Memorandum

SUBJECT: LUC-2017-98 533 MOUNT CARGILL ROAD, COMMENT

FROM LANDSCAPE ARCHITECT.

<u>Photo 1.</u> View from Mount Cargill Road towards the south. The dwelling is proposed around the middle of exotic planting on the west side of Weatherston Hill, to the right.

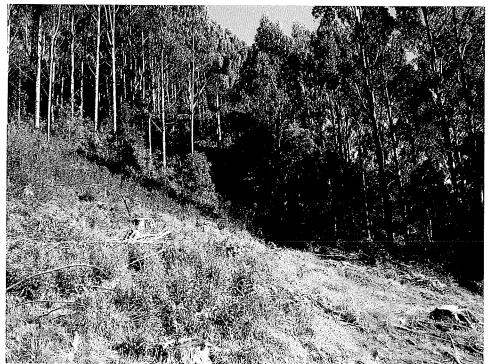
In my opinion there is potential for some of these features to be diminished, at least at the proposed early stage. The natural landform totally dominates the area at the moment, even although the site has exotic woodlot plantings. Establishing a dwelling here, with removal of some woodlot screen planting would not only introduce a new "human-made landscape element", but may have a potentially more than minor adverse effect on the quality of longer distance views from the north and east. Appended photographs indicate this potential effect.
